SERVICE INSTRUCTIONS

No. 1057
ATA Code 27-20

SUBJECT: FLIGHT CONTROLS - REPLACEMENT OF THE ELEVATOR AND RUDDER TAB PUSH RODS

EFFECTIVITY: BEECHCRAFT Duchess 76, serials ME-1 through ME-6, ME-8 through ME-62 and ME-66.

Figure 1.

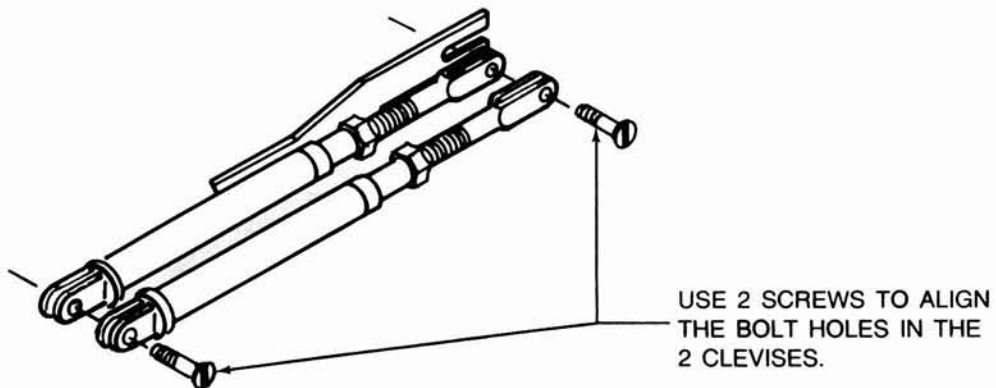
NOTE: ON SOME INSTALLATIONS IT MAY BE NECESSARY TO DRILL A NEW .060 DIA. INSPECTION HOLE IN THE AFT END OF THE TRIM TAB PUSH ROD; .375 FORWARD OF AFT EDGE OF TUBE AND 90° TO EXISTING INSPECTION HOLE.

2 SCREWS ALIGNED IN THE BOLT HOLES IN THE 2 CLEVISES.

SCREWS ARE NOT LINED UP EVENLY. MUST BE IN LINE.

The clevis slot at the actuator (fwd.) end of the rod must be in the same plane as the tab horn clevis slot. (See figure 1.)

5. Adjust the new P/N 105-520048-1 elevator trim tab push rods to the measured length in step 4. (See figure 1.) Be certain to maintain the left and right identification of the rods when adjusting the new rods for correct length.

Figure 2.

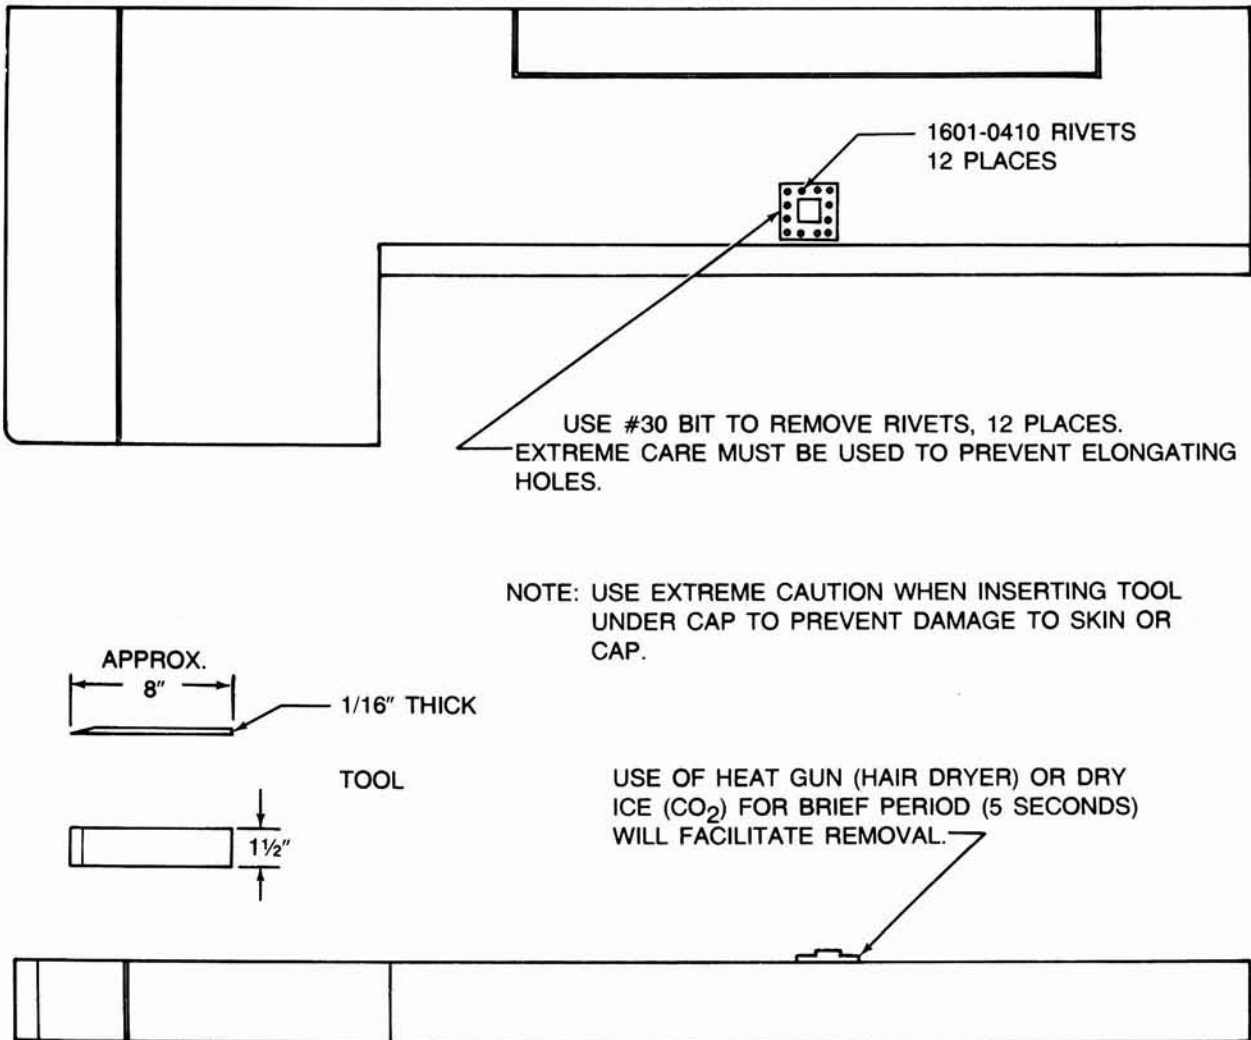
1. Disconnect the aft ends of the elevator trim tab push rods.
2. Carefully drill out the rivets from around the cap over the forward end of the elevator trim tab push rod on the upper leading edge of the elevator. (See figure 2.)
3. Using a thin piece of steel, approximately 1/16 inch X 1½ inches X 8 inches, with a sharpened edge, separate the cover from the elevator skin.
4. Disconnect the elevator trim push rods from the actuators and remove the push rods. Identify each push rod as left or right. Measure the length between the push rod bolt holes or use the existing rods as a jig for new rod length by using two long 10-32 AN bolts through the attach bolt holes.

- safety wire which was used to secure the actuator shaft in step 4.
7. Apply a thin even coat of Permatex No. 3 (P/N of Permatex Inc., Kansas City, Ks.) (obtain locally) to the surface of the cap which was removed in step 3.
 8. Place the cap in position and secure it with 1601-0410 rivets.
